Applicant : Nguyen et al.
Serial No. : 10/778,013
Filed : February 11, 2004
Page : 14 of 16

Attorney's Docket No.: 13854-062001

Amendments to the Drawings:

Fig 7

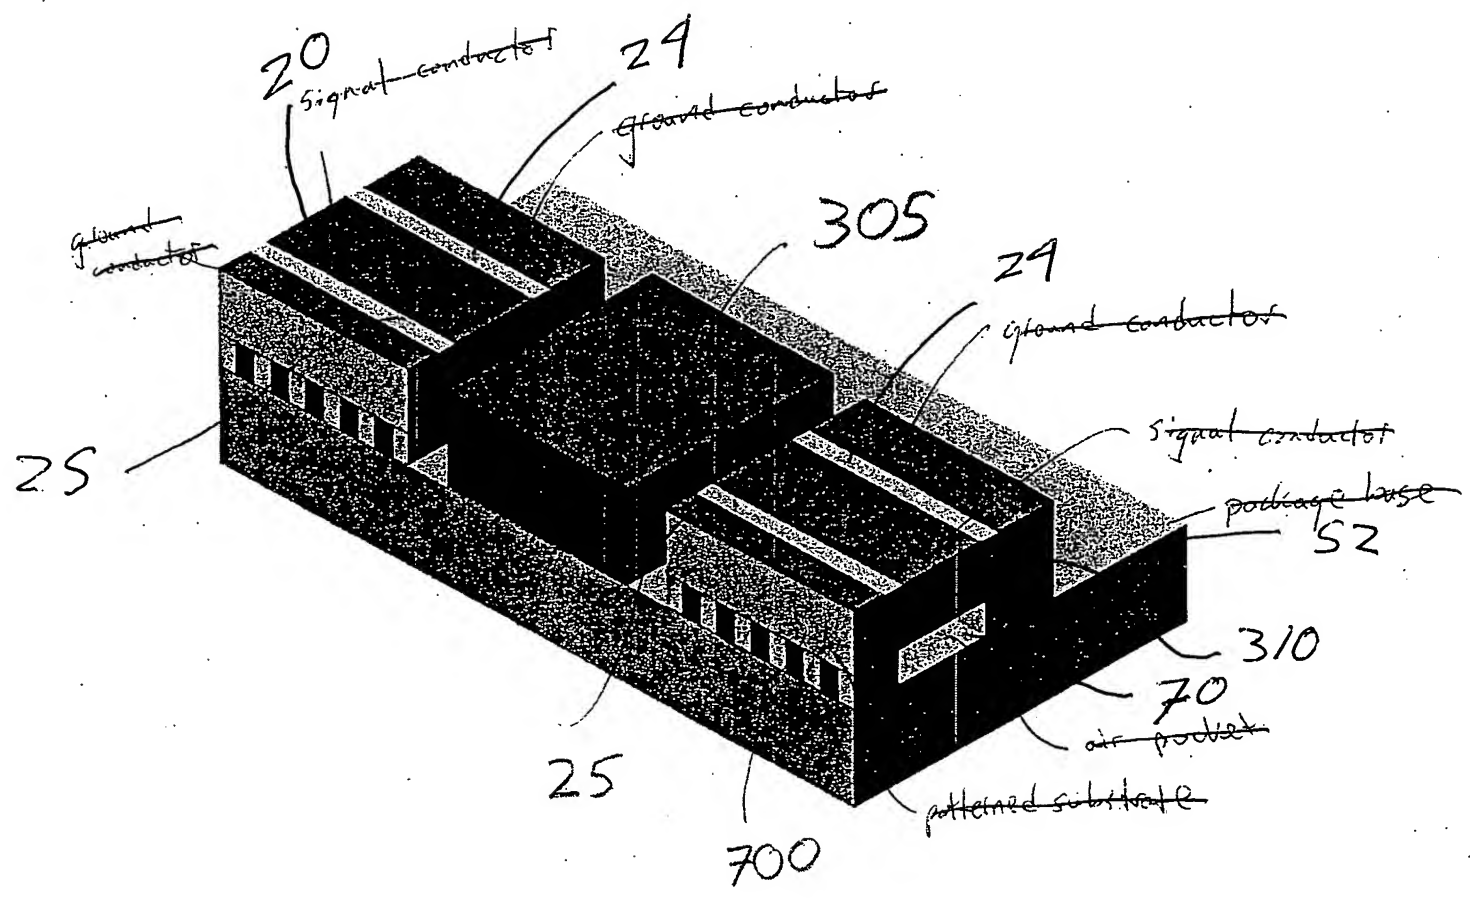
In Figure 7, descriptive language as been deleted and reference numerals 20, 24, 25, 52, 70 and 310 have been added.

The Examiner has pointed out numerous informalities regarding the specification and Figure 7. Applicant believes these informalities have been corrected with the included amendments to the specification and the replacement drawing sheet including correction of Figure 7. No new matter has been added.

The attached replacement sheet of drawings includes changes to Fig. 7 and replaces the original sheet including Fig. 7.
